Kerferd Rd, Montague St,
Herbert St - Intersection,
Albert Park

Road Safety Audit

Audit Stage: Existing Conditions

Report for City of Port Phillip

(the picture to the right is a Dutch style protected roundabout. Similar examples can be seen on Moray Street, South Melbourne. Design work would be required to cater for the intersection stagger between side roads)

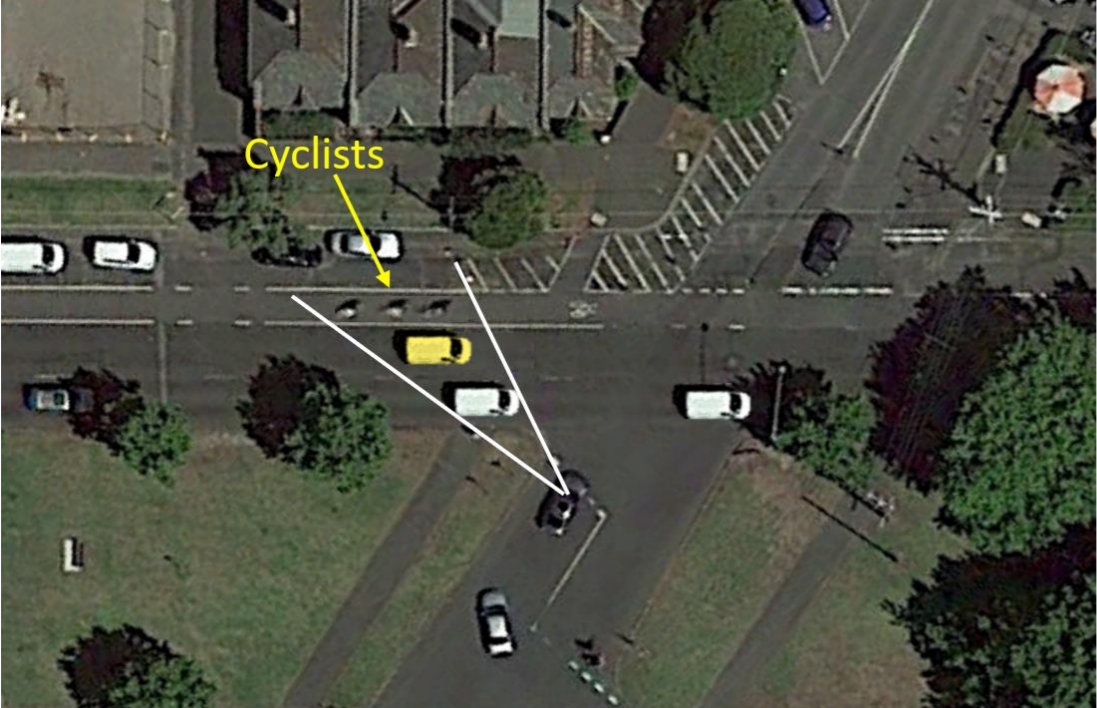
- 7. **Converting the intersection to a protected roundabout** ie. with appropriate pedestrian and cyclist facilities.

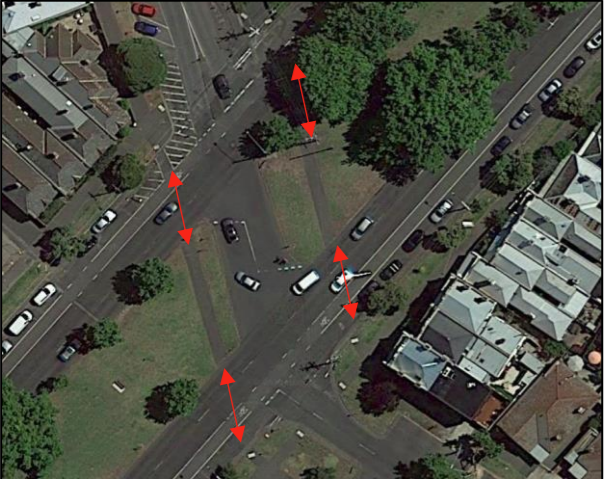
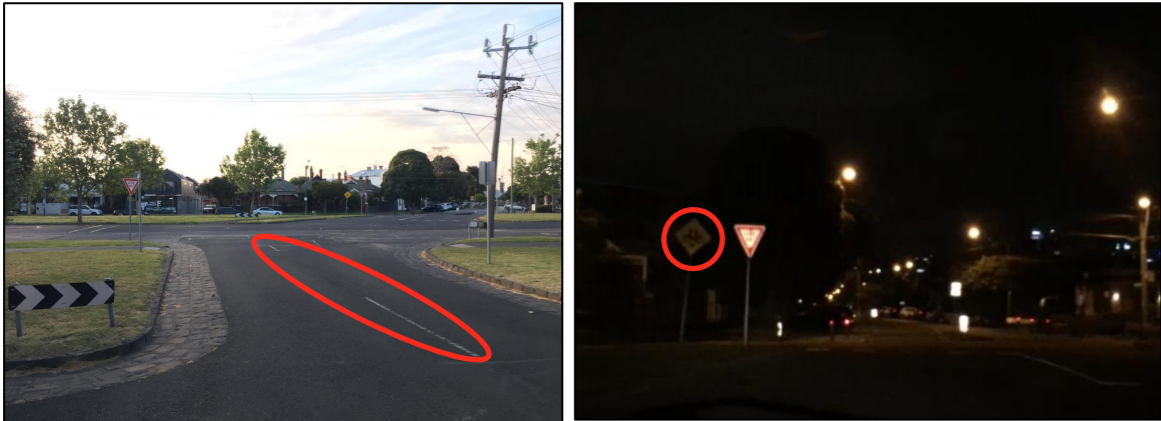
Audit Findings	Level of Risk	Safe System Energy	Recommendations P – Primary ST – Step Towards S – Supporting N – Non-Safe System	Responsible Officer	
				Accept Yes/No	Comments
<p>4.3 Strike Hazards in Roadway</p> <p>1. Where Montague Street intersects Kerferd Road, and to the northeast of Herbert Street, wooden bollards and signage have been installed in front of the kerb. It is assumed that these treatments in conjunction with pavement markings have been installed to a pseudo kerb-outstand thus reducing the speed of left turning vehicles and providing better sight lines for exiting vehicles. While the Auditors support the principles and compliment the low-cost innovative treatment, the bollards and signs in these locations are close to the cyclist running lane and could pose a strike hazard to a cyclist, motorcyclist or a vehicle.</p>	<p>Occasional Minor Medium</p>	<p>Within tolerable levels</p>	<p>Consider measures that provide a safe road environment to all road users, such measures could include:</p> <ul style="list-style-type: none"> Removing bollards and signage, installing kerb extensions, reinstalling compliant bollards and signage as required (S). <p>Additional raised thresholds could be considered for pedestrian safety as per the recommendations below.</p>
